SUBJECT: Indian Point Nuclear Generating Unit No.3  
Docket No. 50-286  
**Reply to Request for Additional Information  
Regarding Proposed License Amendment for  
1.4% Measurement Uncertainty Recapture Power Uprate**

**Clarification; Response to Question 5, Indian Point 3 RAI dated 8/26/02**

*This information supplements and clarifies the response to the subject RAI, which asked: "Were the flow elements [to be used in the IP 3 uprate] tested in a plant specific geometry?"*

Figure 1

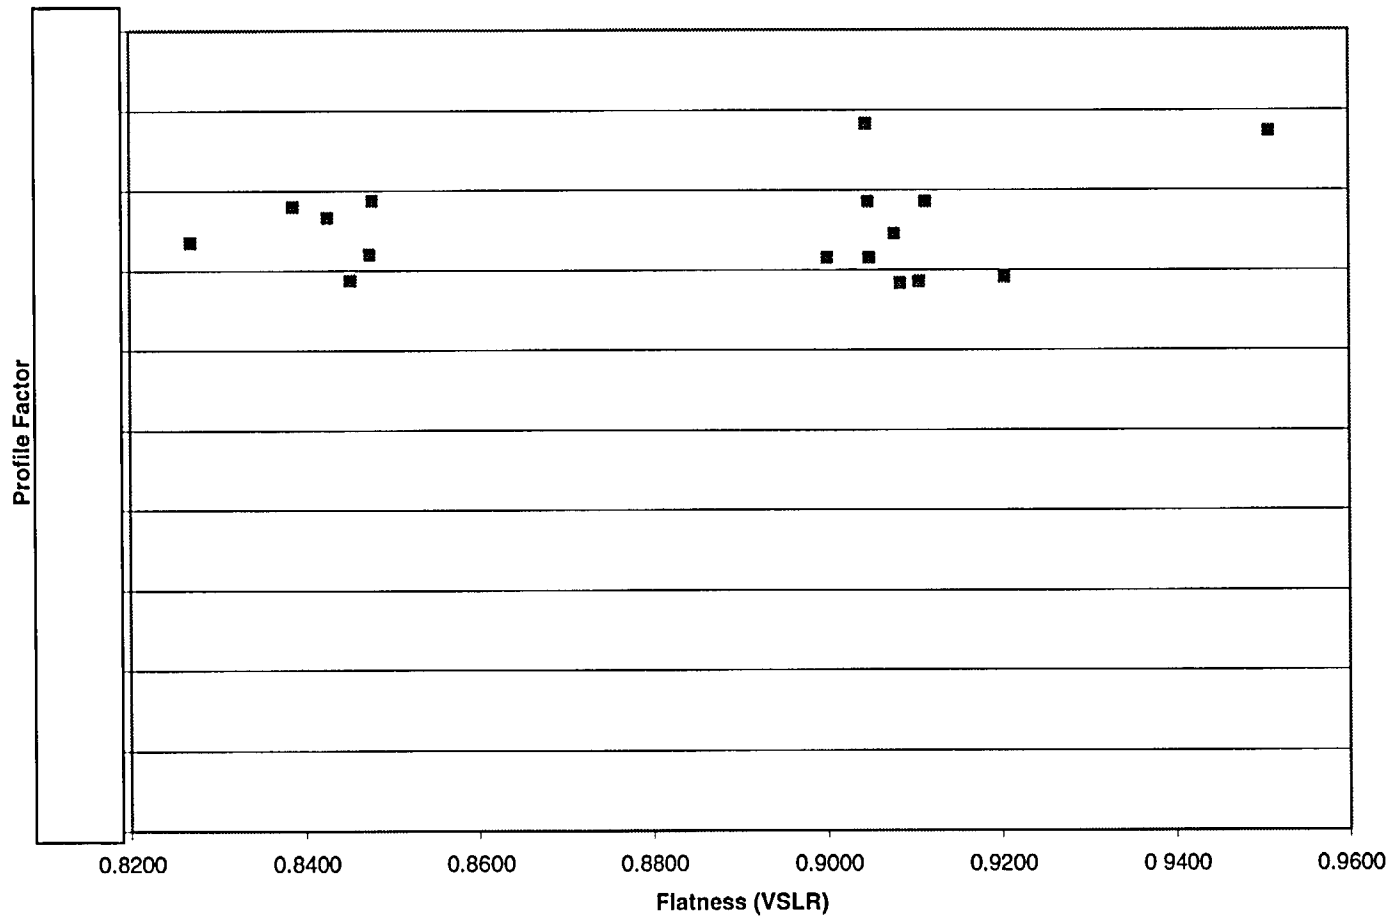
Results are shown in Figures 1 and 2. Figure 1 shows the sensitivity to flatness. The cluster of data on the left—for flatness in the 0.83 to 0.85 range—are the straight pipe data. The cluster of data on the right—flatness 0.90 and up—are with complex upstream geometries. The latter group embraces the flatness ratios measured at IP 3. The mean Profile Factors for the two data sets are essentially the same— [REDACTED] band about the straight pipe mean bounds all the data, including some for hydraulic conditions substantially more extreme than those at IP3.
